Title TCS Laser Chiller Summing Board			
Size: A	DCC Number: D1500265		Ligo Project California Institute of Technology Massachusetts Institute of Technology 
Drawn by: Ben Abbott	Date: 11/16/2016	Revision: v2	
File: C:\restored\Ben\AOS\TCS Stuff\Laser Chiller Summing\LaserChillerSumming.SchDoc 11/16/2016 10:06 AM Sheet 1 of 2

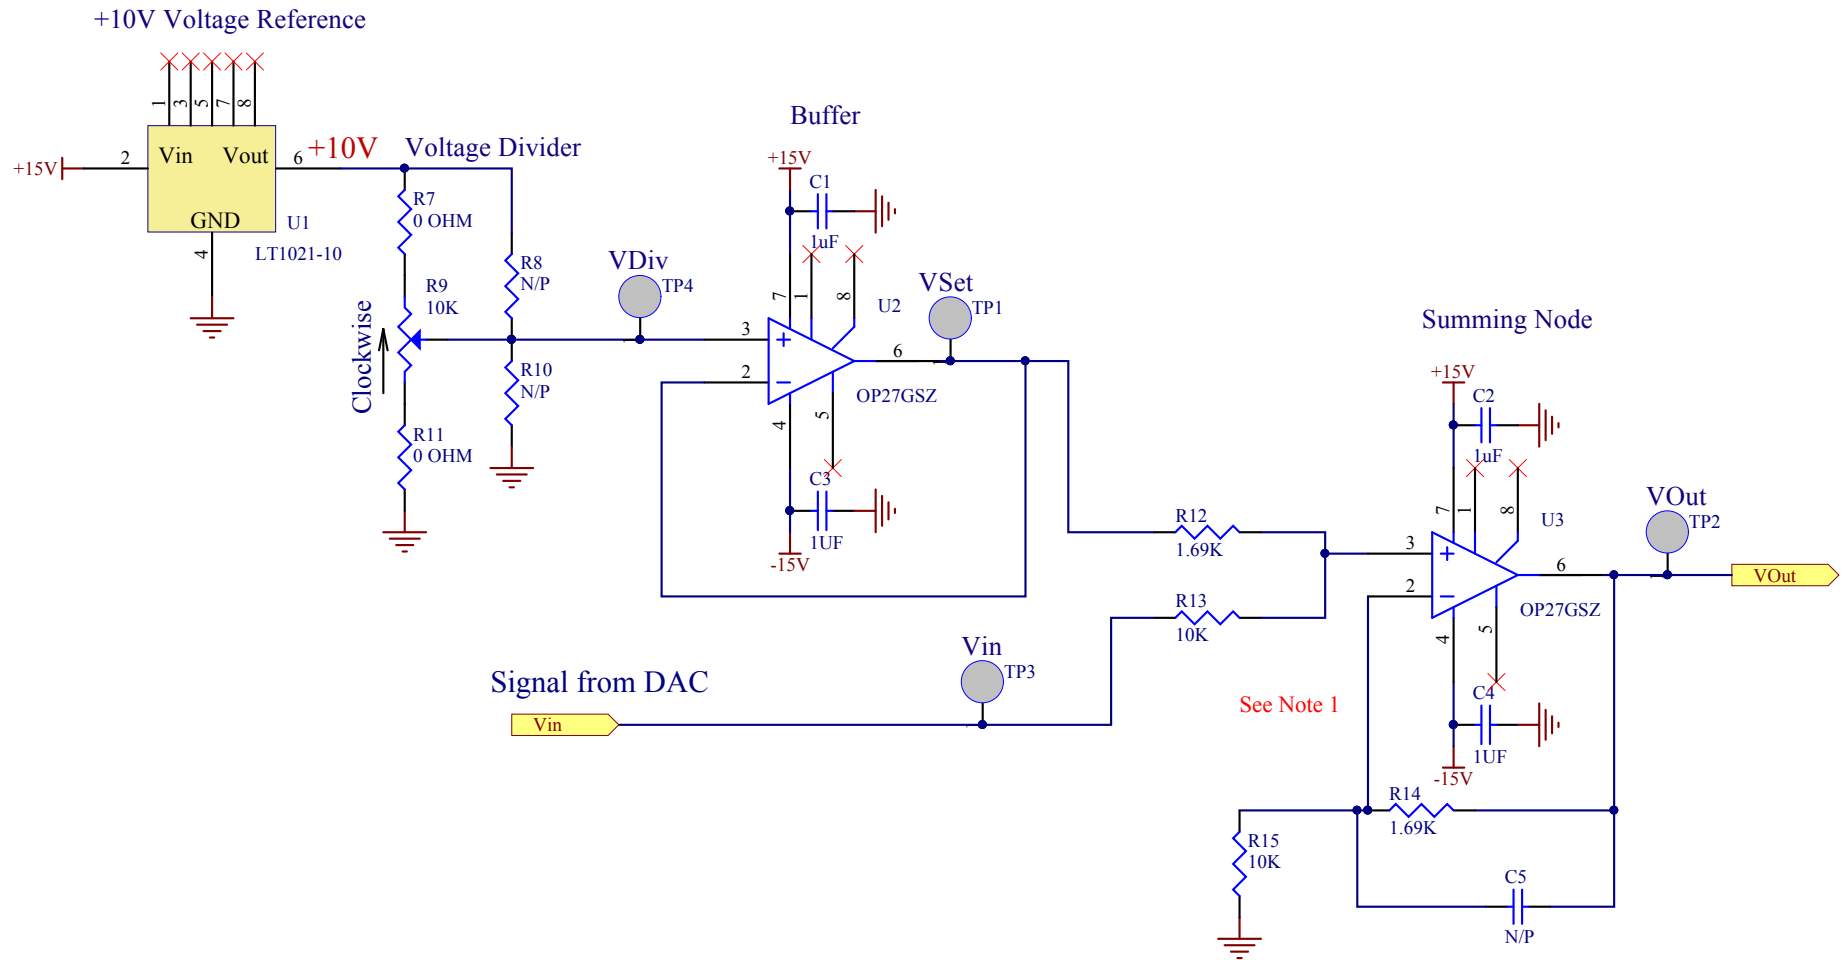
Note 1:
 R12, R13, R14 and R15 have been changed in order to reduce the gain of the DAC path to 0.17V/V. This was done to stop DAC reboots from tripping the chiller.
